Subject: Annual Inspection Report Jeremiah Denton Airport

ANNUAL INSPECTION REPORT

JEREMIAH DENTON AIRPORT DAUPHIN ISLAND, ALABAMA

JEREMIAH DENTON AIRPORT Dauphin Island, AL November 2, 2022 RWY 30 Obstruction Evaluation

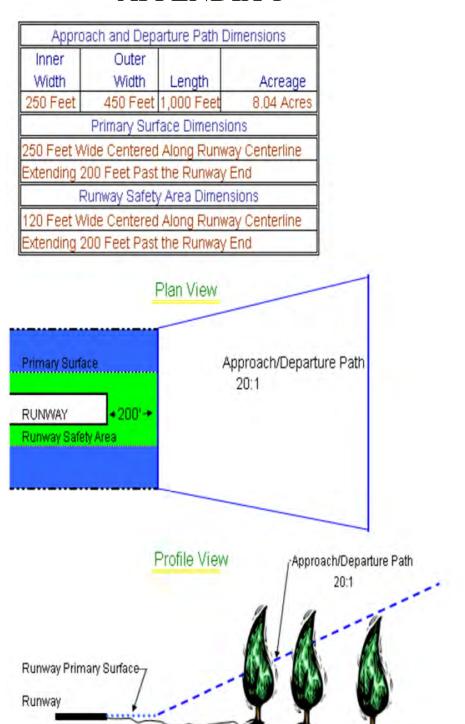
- 4. Tree 34' Abv. RWY
 747' From Rwy End
 106' Left of CL
 20:1 Obst. Clnc. (FAA)
- 5. Tree 61' Abv. RWY End 979' From RWY End 216' Left of CL 15:1 Obst. Clnc. (FAA)
- 6. Pole 37' Abv. RWY End 771' From RWY End 290' Left of CL 19:1 Obst. Clnc. (FAA)
